FOUNDATION INVESTIGATION REPORT

FOUNDATION INVESTIGATION REPORT
For
Hwy. 27 Culvert Replacement
at Sta. 16+825, Township of Vespra
W.P. 210-85-01
District 5, Owen Sound

Re: Review of Preliminary Drawing
Culvert Replacement at Hwy. 27
Township of Vespra
W.P. 210-85-01
District 5, Owen Sound

PLACE 3 1630 x 1120 x 22.0 CSPA CULVERTS

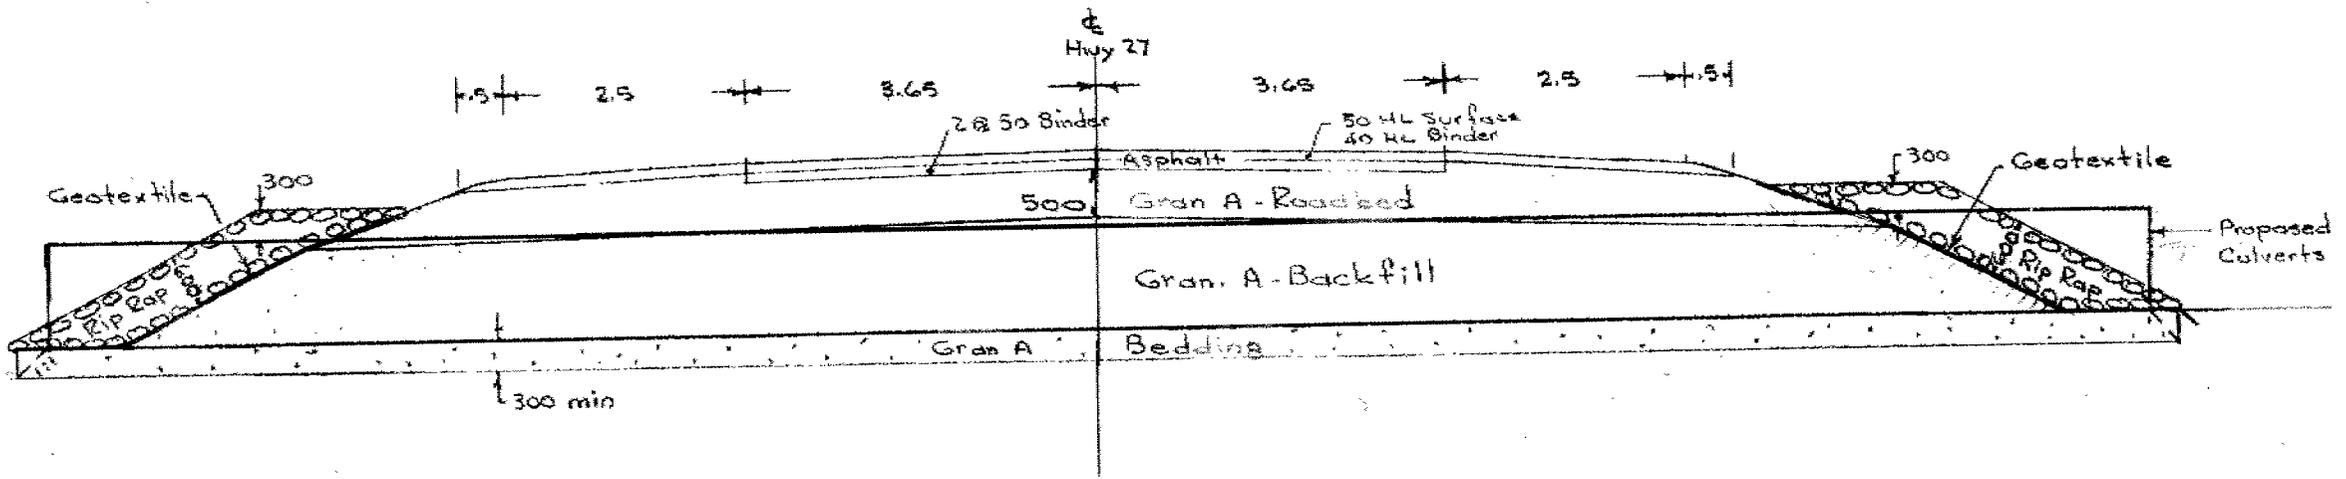
Based on our review, it is concluded that the design confirms our recommendations. However, it should be noted that for the 600 mm rock protection, geotextile underneath the rip-rap be eliminated since the potential sliding would occur along the surface of the geotextile and the angular rock would puncture the geotextile.

It is also understood that the designer would like to eliminate the proposed clay sealer behind a 600 mm layer of rip-rap due to the difficulty of installation. However, it is still our opinion that a 1 m thick blanket of clay material should be placed at the culvert inlet as recommended in our report (WP 210-85-01, Dec. 10/90) in order to prevent piping around the culvert. This technique has been used successfully for the similar situation of high water level in Central and Northwestern Regions for a long period of time. Alternatively, interlocking sheet piling or wing walls with cut-off wall can be considered if the clay seal is not favourable. However, it should be noted that the alternatives would be much more expensive than the clay sealing.
